The Town of Hilton Head Island Regular Design Review Board Meeting

Tuesday, July 27, 2010

DESIGN TEAM/ DRB COMMENT SHEET

PROJECT South Island PSD

1
A-3

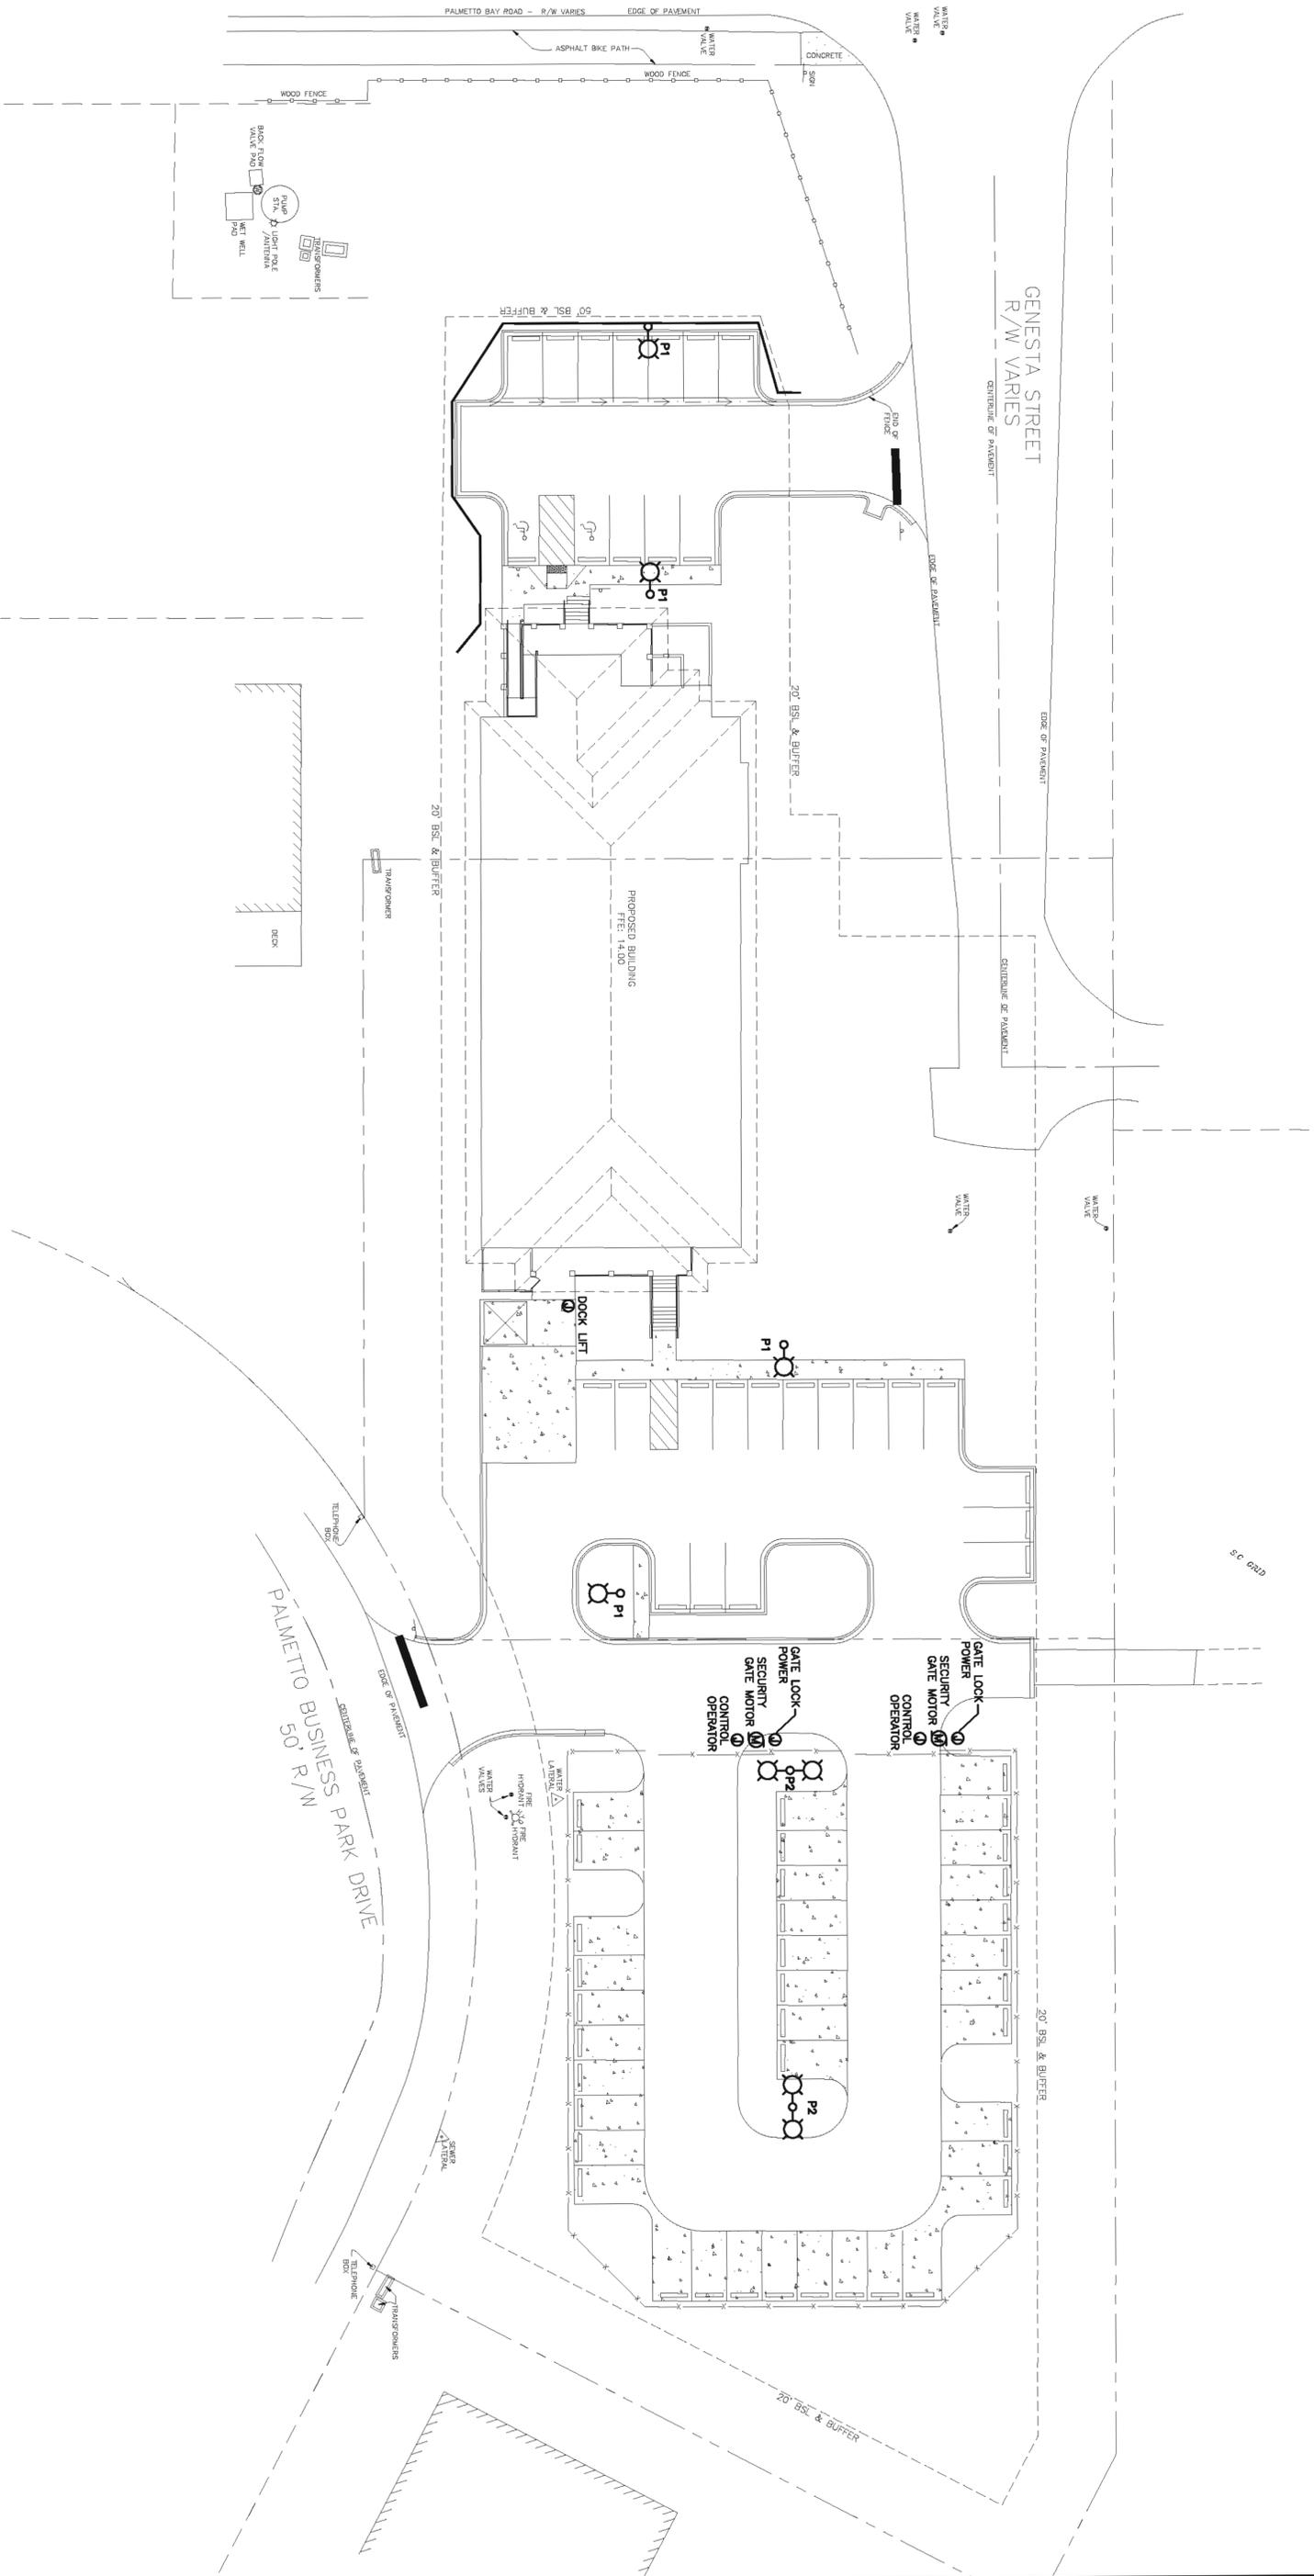
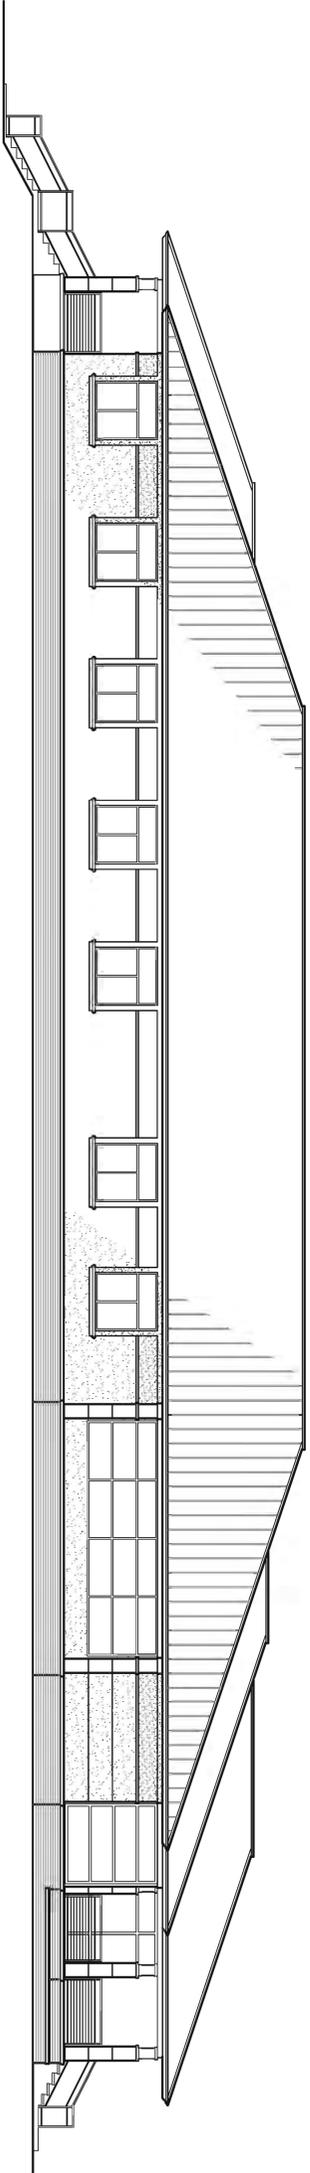
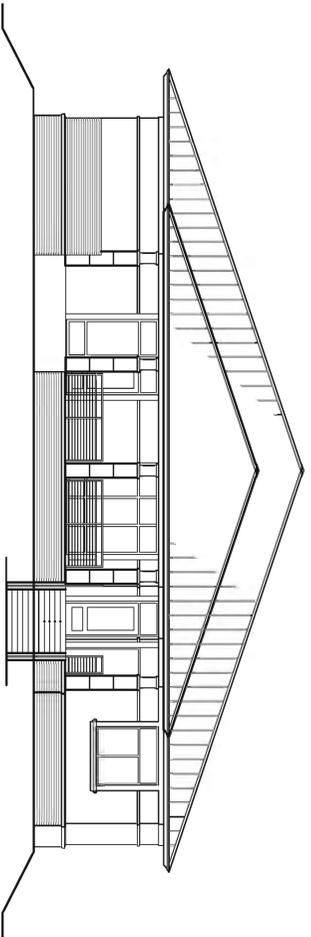
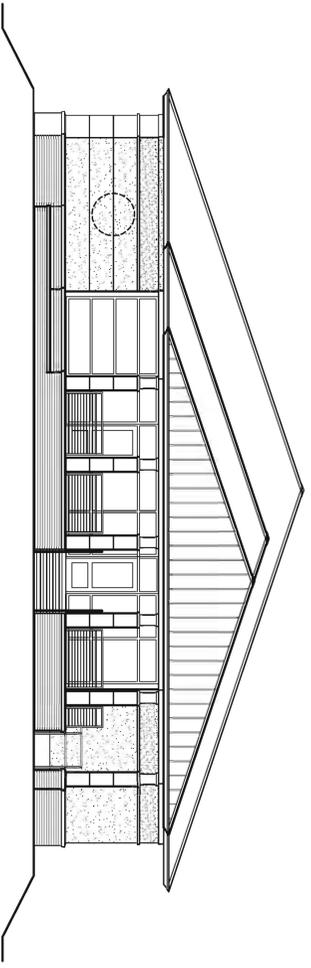
The Board's comments regarding window rhythm and the roof color have been sufficiently addressed. Staff's comments about the service yard fence and screening has, as well. Chain link should be vinyl coated- dark green, or black. While the aluminum finish of the windows has little precedence, it lends itself with the cooler palette of the roof.

PLANT SCHEDULE / DETAILS
PROJECT NO. : 0921
CHECKED BY : XXX
DRAWN BY : XXX
DATE OF ISSUE : 04/19/2010

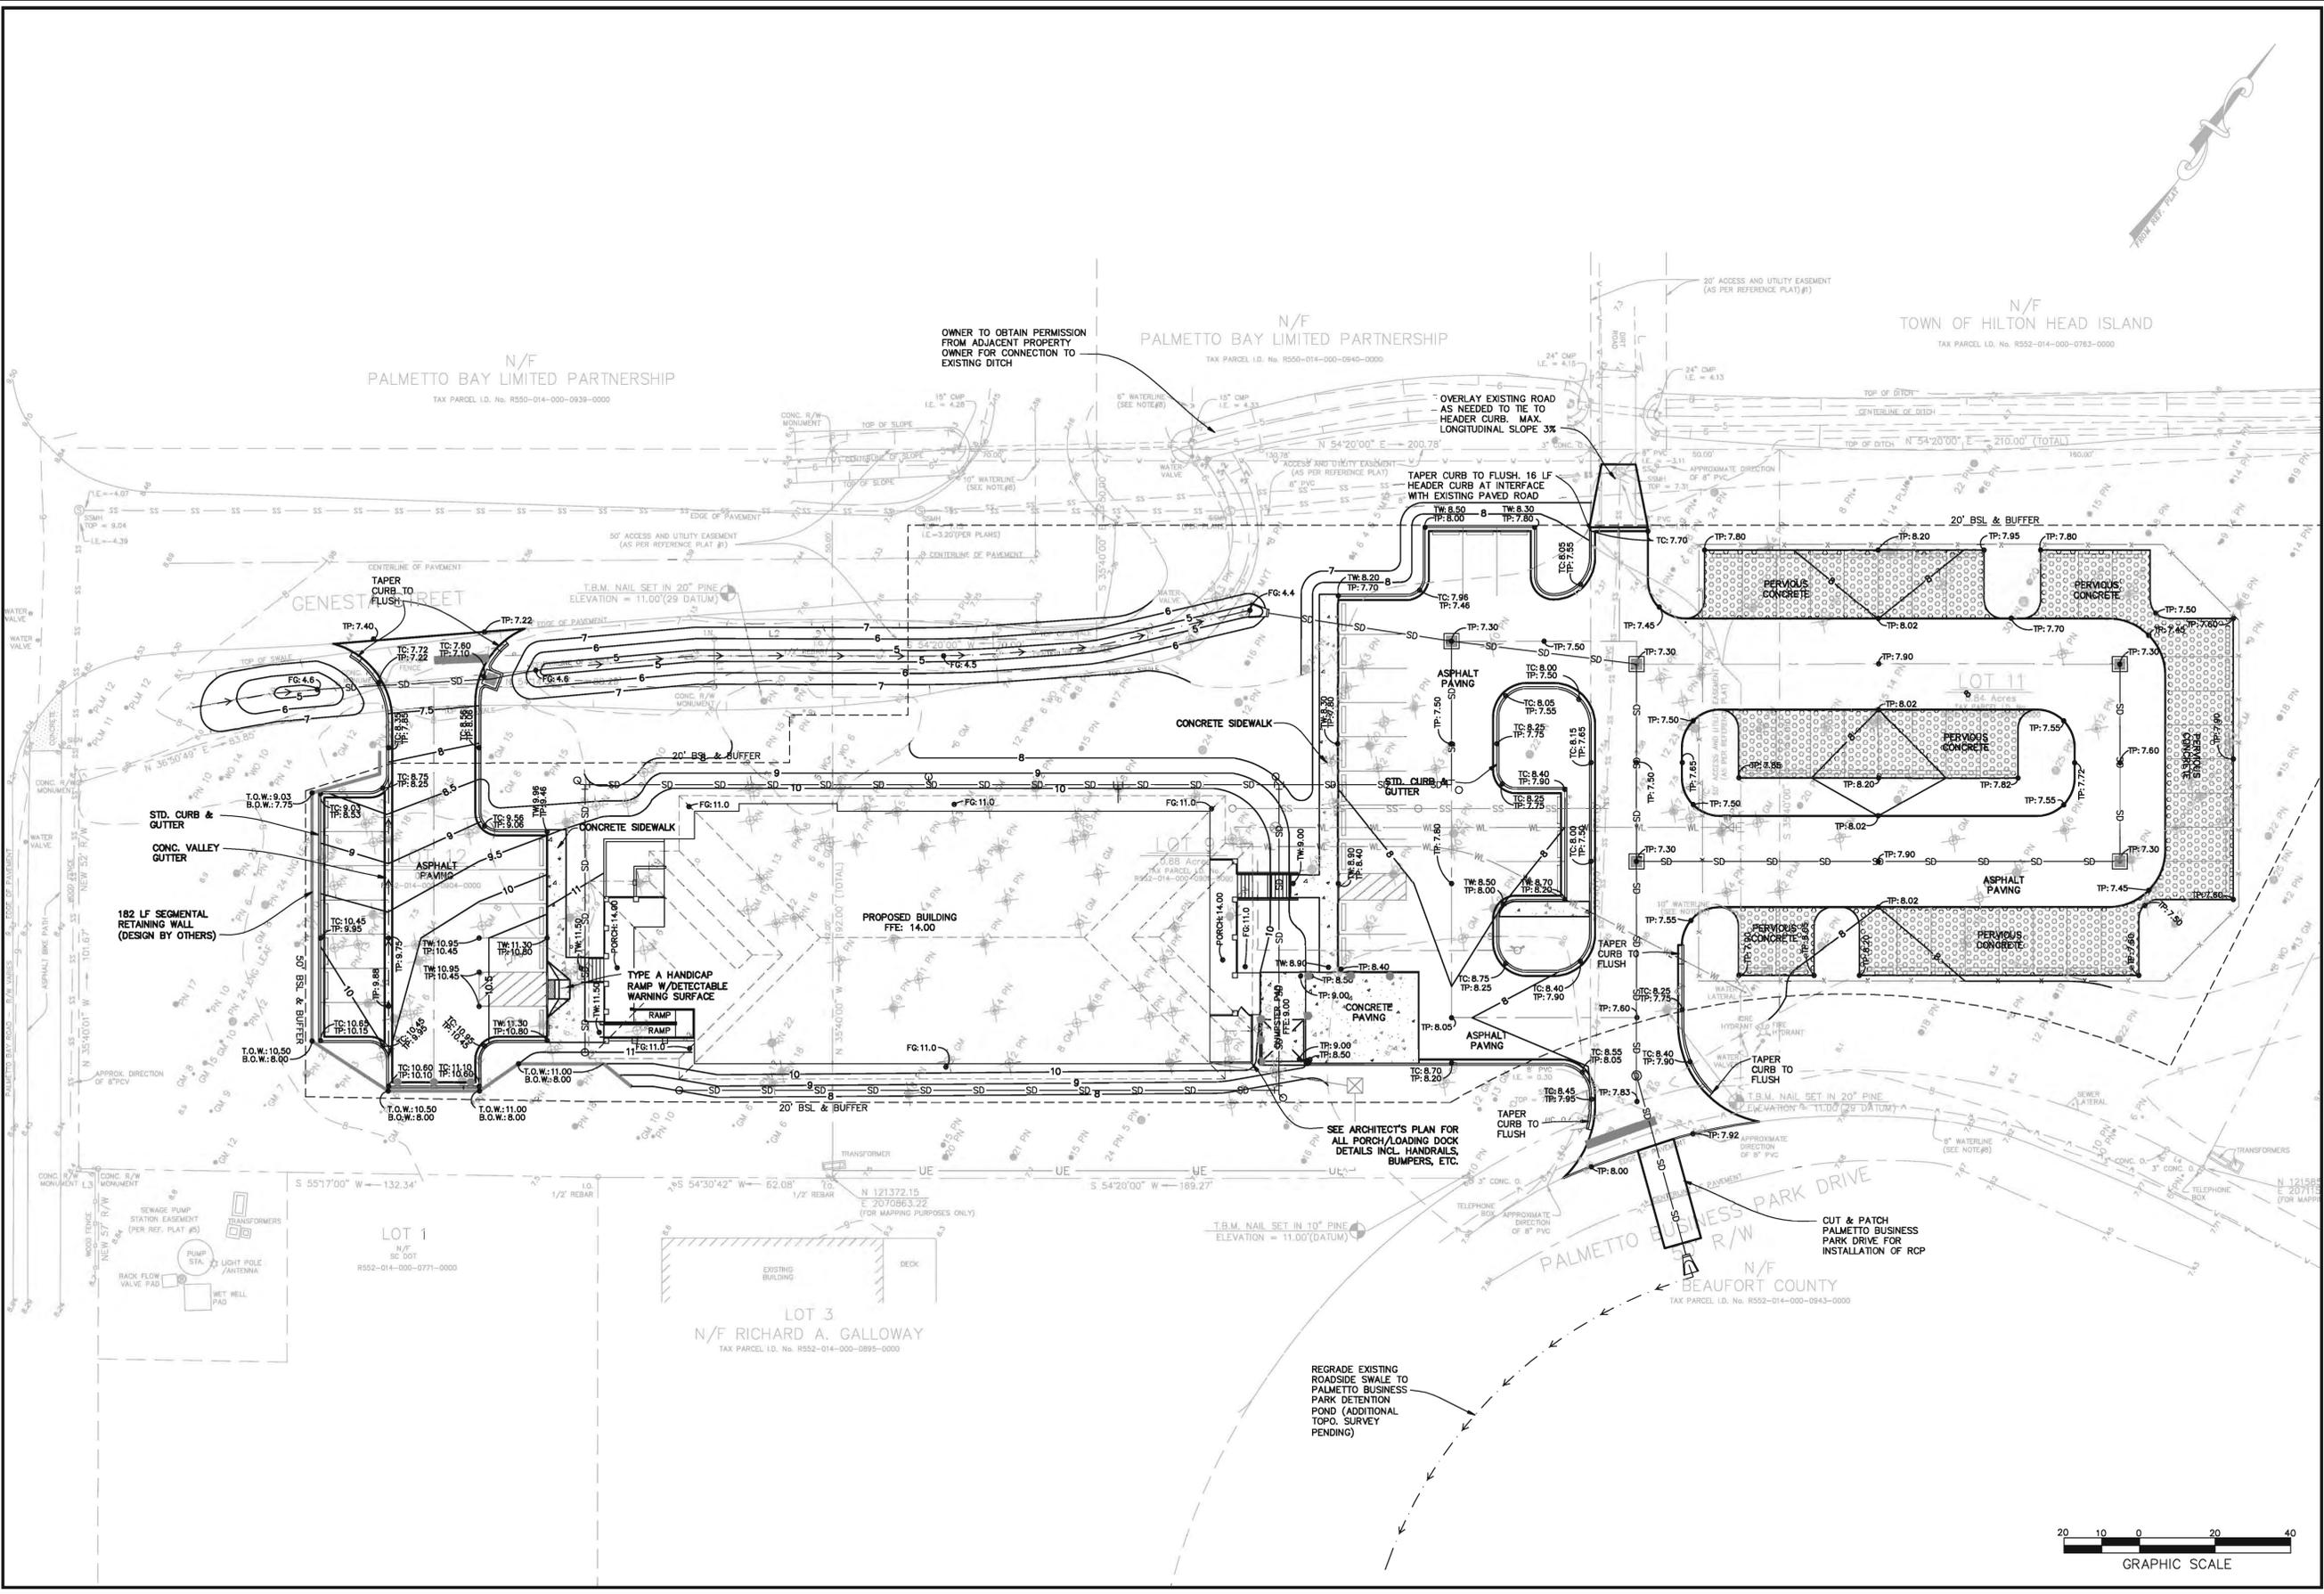
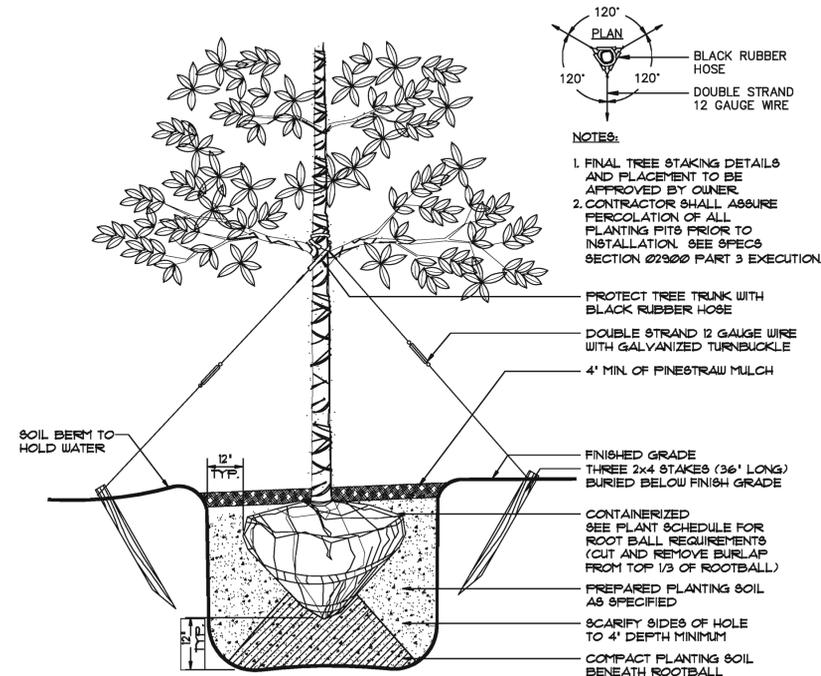
DESIGN GUIDE/LMO CRITERIA	COMPLIES YES/NO/NA	COMMENTS OR CONDITIONS
An effort has been made to preserve existing trees and under story plants		Florida maples are not found on HHI---substitute Red maples (Acer rubrum) Sweetbay magnolias do not do well on the island; substitute Loblolly Bay.
Supplemental and replacement trees meet LMO requirements for size, species and number		
Wetlands if present are avoided and the required buffers are maintained		
Sand dunes if present are not disturbed
